# Appendix A: Responses to expert's letter dated 22nd November 2024

## Summary of responses

This PDF document shows Beca replies (in blue) to the letter prepared by Mr Lines and Dr Hargraves dated 22nd November 2024. These responses should be read in conjunction with the text in the Statement of Reply of Dan Chamberose (27 November 2024) document under Section 5. SLOPE INSTABILITY SUSCEPTIBILITY OVERLAYS AND DEBRIS RUN-OUT OVERLAY – ACCURACY OF THE OVERLAYS.

Figure A 8 - Whakatu/Bishopdale Overview

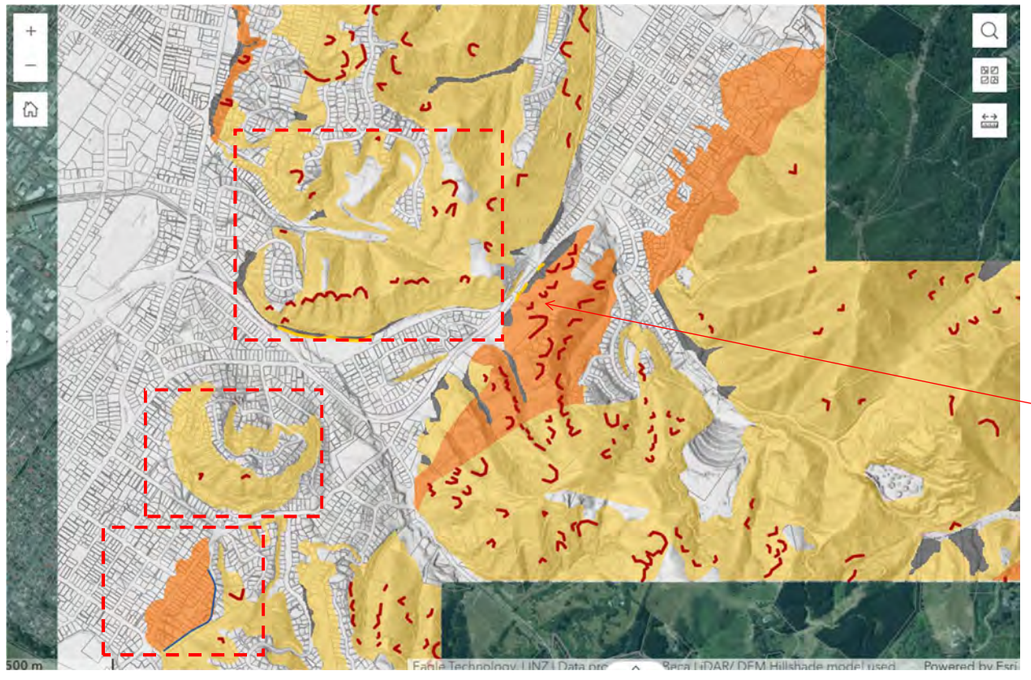
I'm not sure about this Tier 2 zone. The geological they have given us is QMap where Marsden coal measures are not differentiated.

Beca have used the geological map information from Johnston et al. 2021 to define this area. It is identified in these maps as Bishopdale Conglomerate (Kb), therefore, Beca have included areas where the slope angle is greater than 15 degrees as per methodology. The areas outside of this geology unit (that are still Tier 2) are interpreted to be earthflow deposits and included because of this, not because of the underlying geology, as indicated on A24 by Mr Lines and Dr Hargraves. These earthflows were discussed with the SI-TAG following the August 2022 event as there were a number of these that activated in this event and started to encroach on the road. These earthflow features are not shown as such in the inventory as they were identified during the review process and following the SI-TAG discussions, but the inventory was not updated to reflect the change of landslide type. This is a well known area of instability in Nelson.

Kb = Bishopdale Conglomerate downslope area is Braemar (Jb), Kawai Fmt (Jk), and Wakatu Fmt (Jw) - all Jenkins group.

Areas outside of this geology are earthflow deposits as identified in review process and following SI-TAG involvement.

Figure A 9 - Tasman Heights/Coastal View

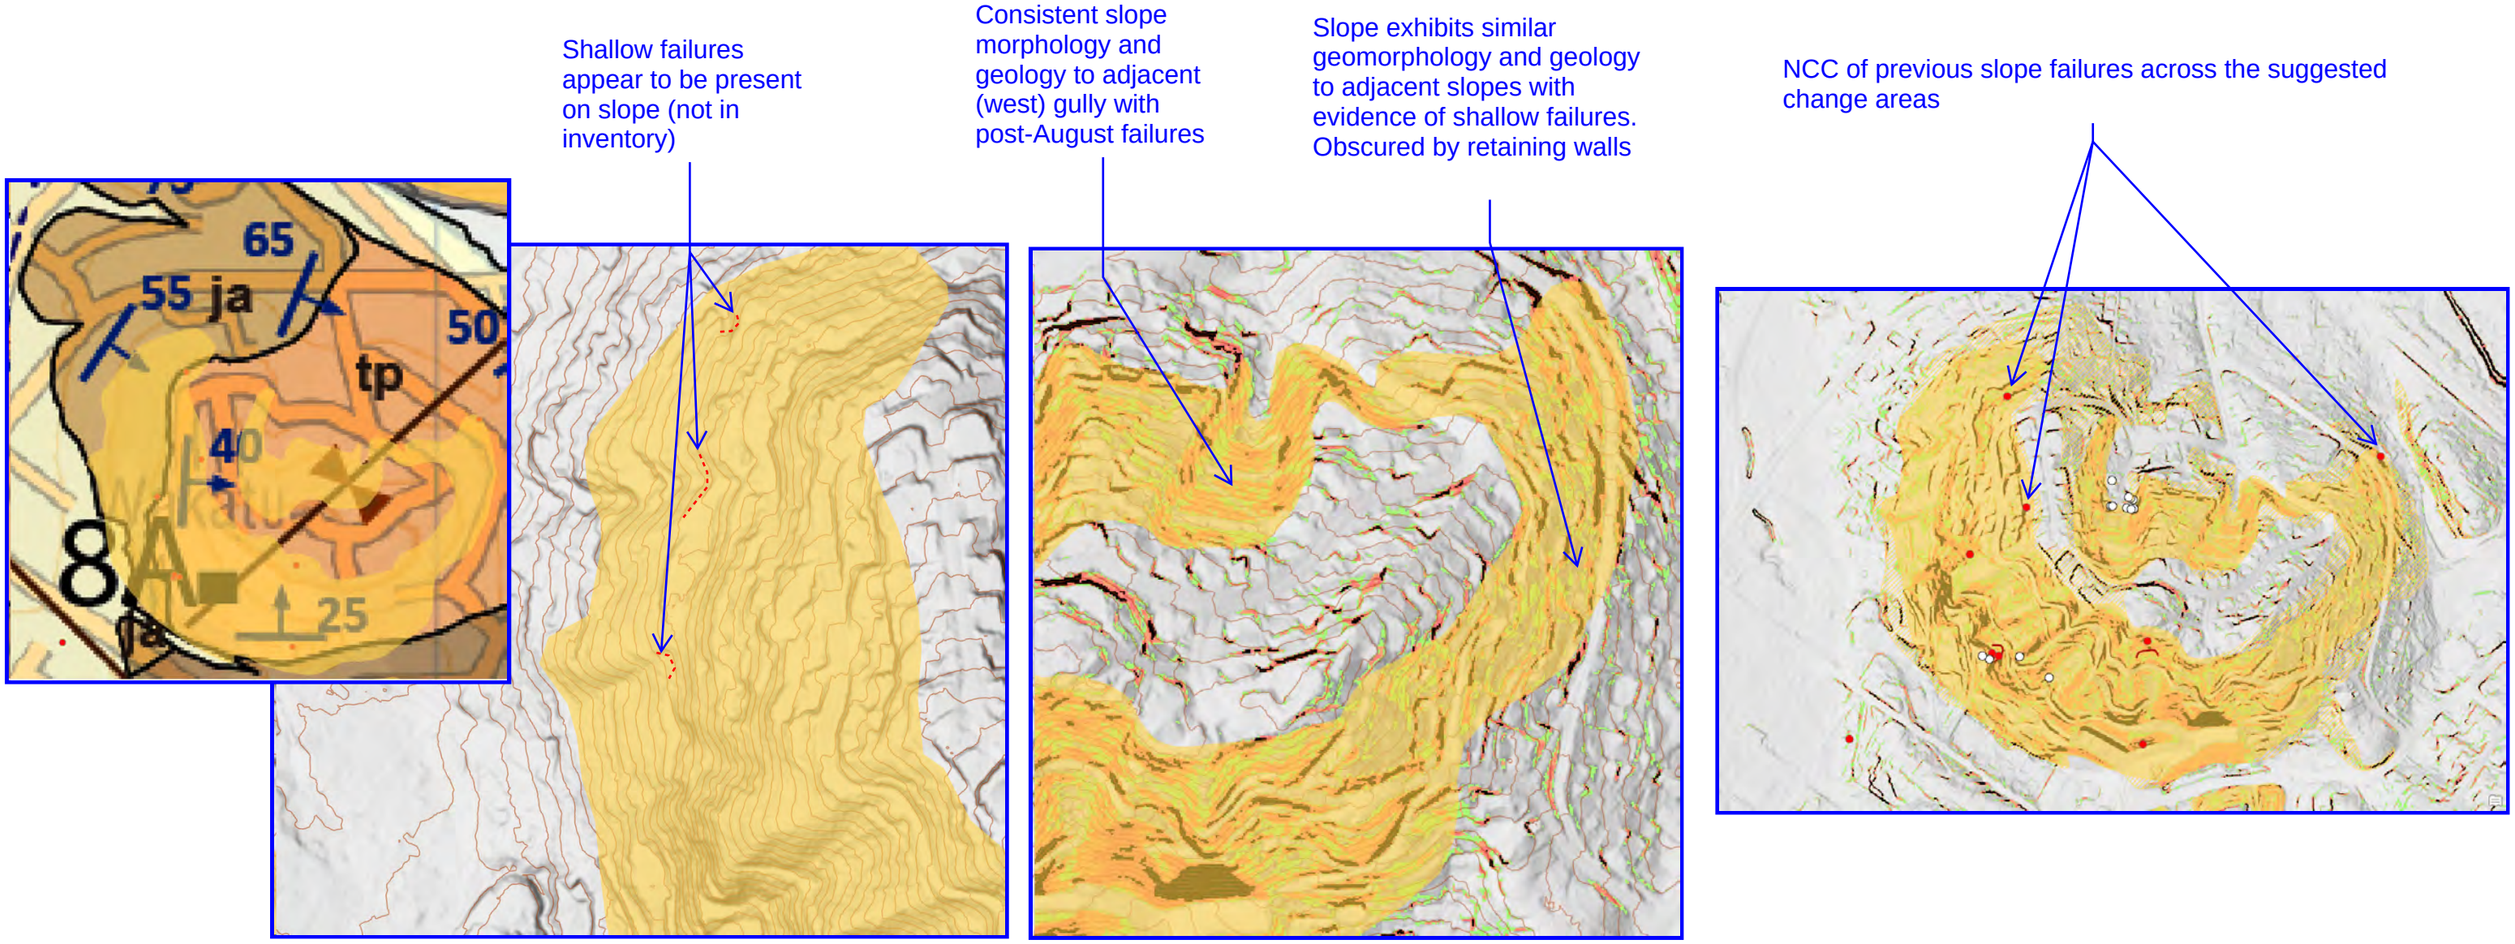
I'm not sure what aerials have been used. But the top of the south maps show failures in this area, which haven't been picked up.

The slope instability inventory has been created in accordance with the AGS guidance and aligns with a ‘basic’ level inventory. The mapping of features is not considered to be an exhaustive record of all instability in the region but is sufficient to show the classification and distribution of slope instability on hillslopes in the region. The aim of the mapping was to capture a representation of slope failure locations and types in the region. In my opinion, this type of inventory, in combination with the other evidence of slope instability (i.e. records provided by NCC and the Post-August 2022 landslide dataset provided by GNS) is sufficient to inform the creation of these slope overlays and aligns with the AGS guidance.

Features/areas identified by the experts are within the extents of the overlay, therefore no change is required.

Figure A 10 - Austin Ward Heights

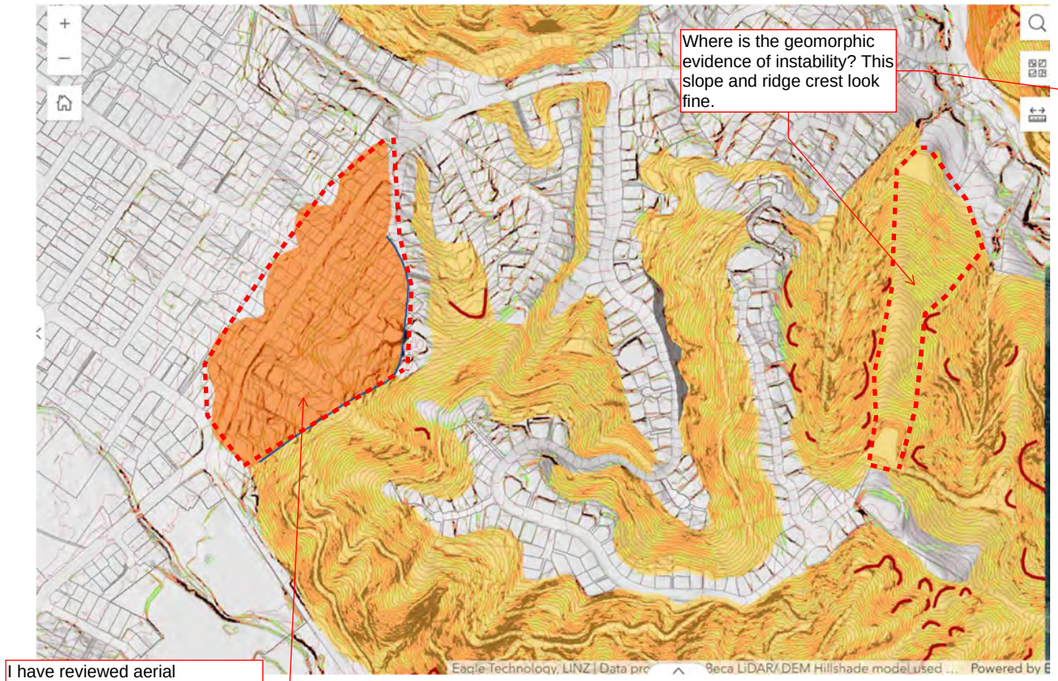
No geomorphic evidence of instability. Some localised areas of >35° terrain, but these seem to correspond to property boundaries and road verges (local retaining?). On balance tier 3 not appropriate for the red areas.

Very little geomorphic evidence of instability mapped. However, there is plenty of it in this area, which also has >35° terrain. On balance tier 3.

The slope instability inventory has been created in accordance with the AGS guidance and aligns with a ‘basic’ level inventory. The mapping of features is not considered to be an exhaustive record of all instability in the region but is sufficient to show the classification and distribution of slope instability on hillslopes in the region. The aim of the mapping was to capture a representation of slope failure locations and types in the region. Please note that there are records provided by NCC of failures across the suggested change areas and features identified in the DEM that are not included in the slope instability inventory (see snip). Also, as described in Beca, 2021 there is evidence of slope instability on nearby slopes. The suggested change areas exhibit consistent geomorphic and geologic conditions to these areas where previous failures have occurred. Therefore, I believe this area should remain within the overlay and no change is required.

Figure A 11 - Kakenga Road

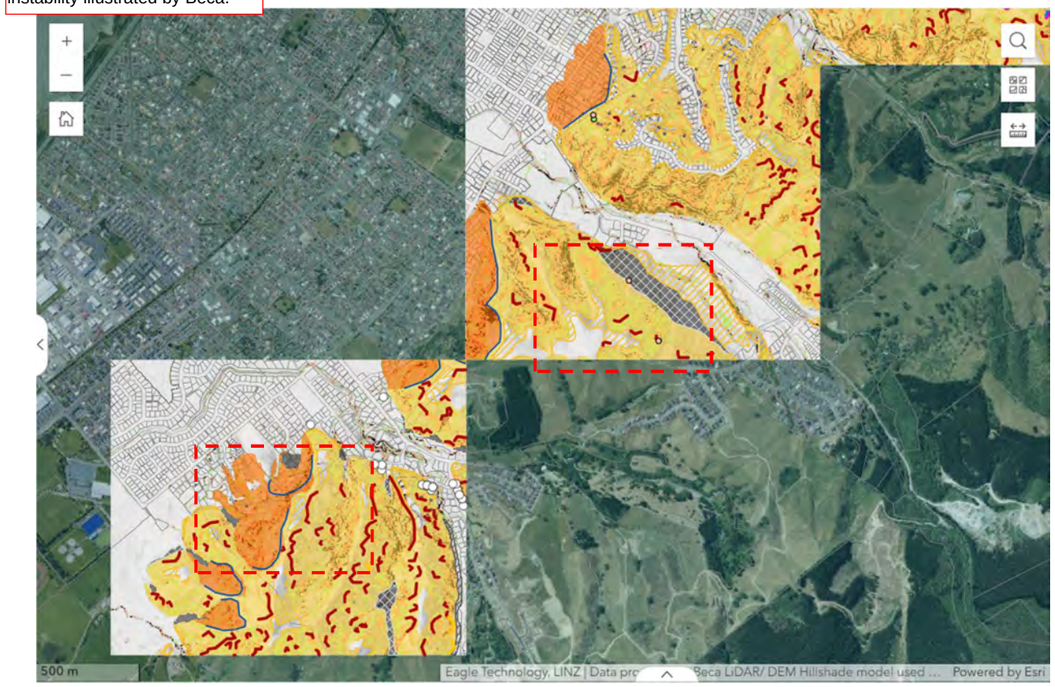
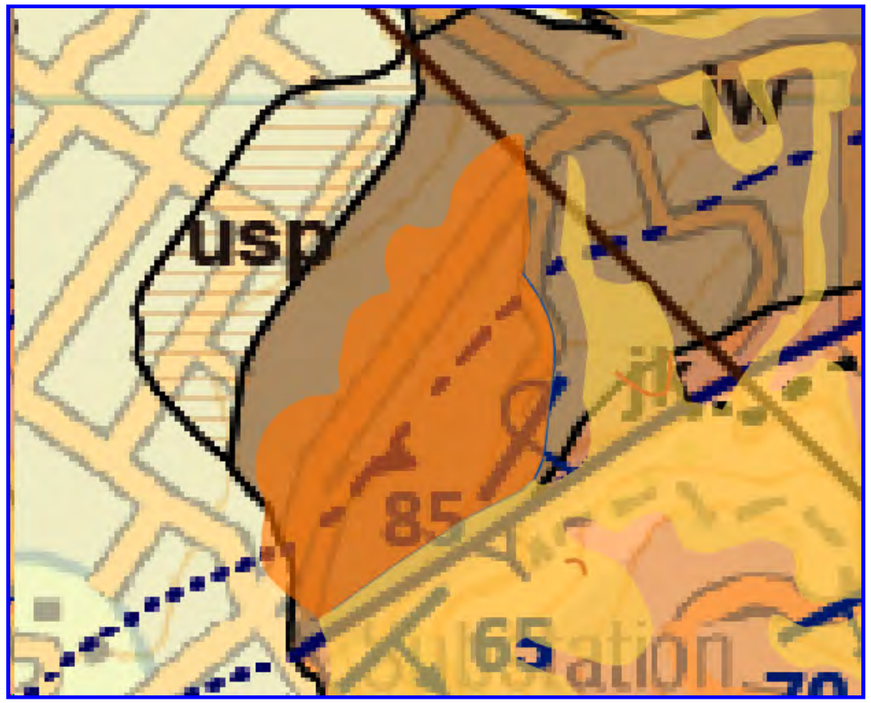
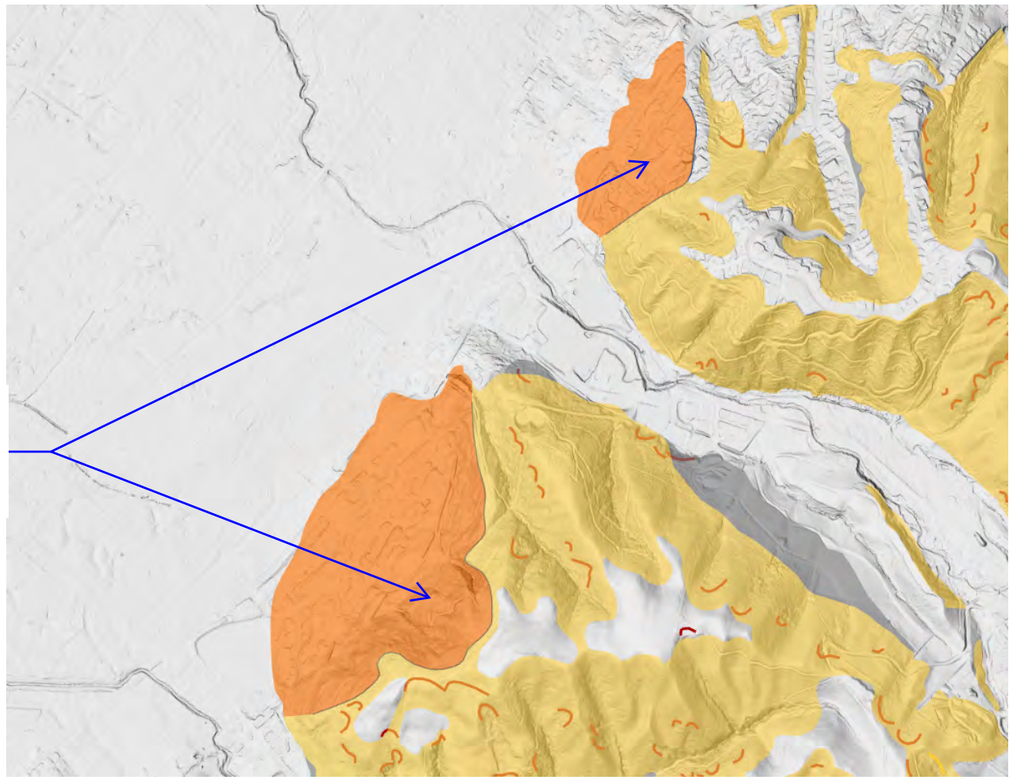
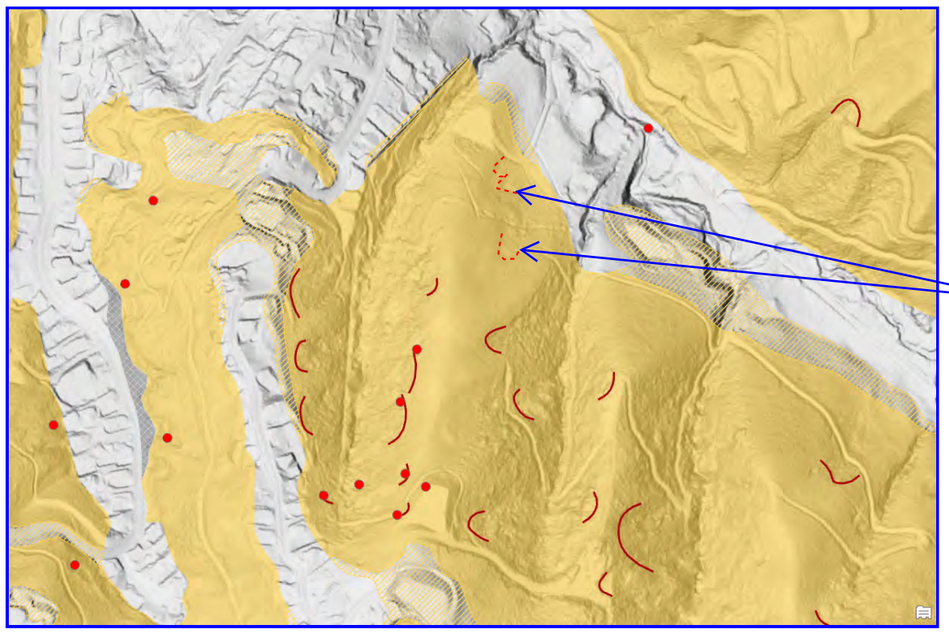
| A11 + A12 A23 | Kakenga Road | The deep-seated slope failure shown in the Beca inventory and assigned to Tier II does not appear to correspond to geomorphic evidence in aerial photographs from 1948 nor 1943. Additionally, a portion of the adjacent hillslope and ridge assigned as Tier III does not contain evidence of instability in the Beca inventory. | Tier 2: This feature was identified in the desktop datasets (DEM) as a deep-seated landslide because its morphology was similar to that of deep landslide features to the south west on adjacent hills. A headscarp feature was interpreted in the DEM and 'fingers' of what was inferred to be landslide debris lower down the slope. More site-specific knowledge may show this is not a deep seated landslide however, however, this is the intent of further investigation as warranted by the susceptibility map. Note that there is presence of shallow instability within this area obscured by landscaping works that are not included in the inventory. Considering a combined overlay, it will not affect the extent of the overlay.<br><br>Tier 3: Please note that there are features interpreted in the DEM that are not included in the slope instability inventory within this area (see snip). These extend into the area identified which is why it is included in the overlays. There are also records provided by NCC of failures in the south of this area. The ridge remains in the overlay because it is too narrow to be excluded as per the methodology. Also, as described in Beca, 2021 there is evidence of slope instability on nearby slopes. The suggested change areas exhibit consistent geomorphic and geologic conditions to these areas where previous failures have occurred. Therefore, I believe this area should remain within the overlay and no change is required. | No overlay update required |

Tier 2: This feature was identified in the desktop datasets (DEM) as a deep seated landslide because its morphology was similar to that of deep landslide features to the south west on adjacent hills. A headscarp feature was interpreted in the DEM and 'fingers' of what was inferred to be landslide debris lower down the slope. More site specific knowledge may show this is not a deep seated landslide however, however, this is the intent of further investigation as warranted by the susceptibility map. Note that there is presence of shallow instability within this area obscured by landscaping works that are not included in the inventory. Considering a combined overlay, it will not affect the extent of the overlay.

Tier 3: Please note that there are features interpreted in the DEM that are not included in the slope instability inventory within this area (see snip). These extend into the area identified which is why it is included in the overlays. There is also records provided by NCC of failures in the south of this area. The ridge remains in the overlay because it is too narrow to be excluded as per the methodology. Also, as described in Beca, 2021 there is evidence of slope instability on nearby slopes. The suggested change areas exhibit consistent geomorphic and geologic conditions to these areas where previous failures have occurred. Therefore, I believe this area should remain within the overlay and no change is required.

Exhibits similar morphology to other deep seated instability to south west

Shallow failures appear to be present on slope (not in inventory map)
